Work Order ID 71085

DRAWING NO. D212-664-141	TITLE XTUBE ASSY (205/212/412 HI FWD)	REV. D	DART AEROSPACE LTD ENGINEERING ORDER		D.E.O. NO. D212-664-141-D-1	SHEET NO. SHEET 1 OF 2	SCALE NTS
DRAWN	CHECKED	MFG. APPR.	APPROVED	DE APPR.			
DATE 11.04.07	DATE 11.04.11	DATE 11.04.12	DATE 11/04/12	DATE 11.04.12

PURPOSE:

ADD AN INSPECTION WINDOW TO UNDERSIDE OF CROSSTUBE.

D212-664-141/-141B
ASSEMBLY DETAIL

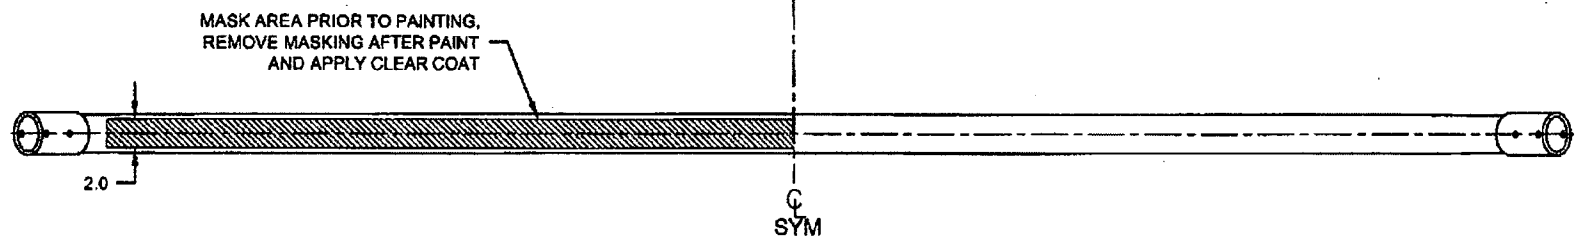
IS:

- 2) FINISH: CHEMICAL CONVERSION COAT PER DART QSI 005 4.1
PRIME INSIDE AND OUTSIDE PER DART QSI 005 4.2
MASK UNDERSIDE OF CROSSTUBE AS SHOWN (HATCHED AREA) AND
PAINT OUTSIDE PER DART QSI 005 4.2
REMOVE MASKING AND APPLY CLEAR COAT
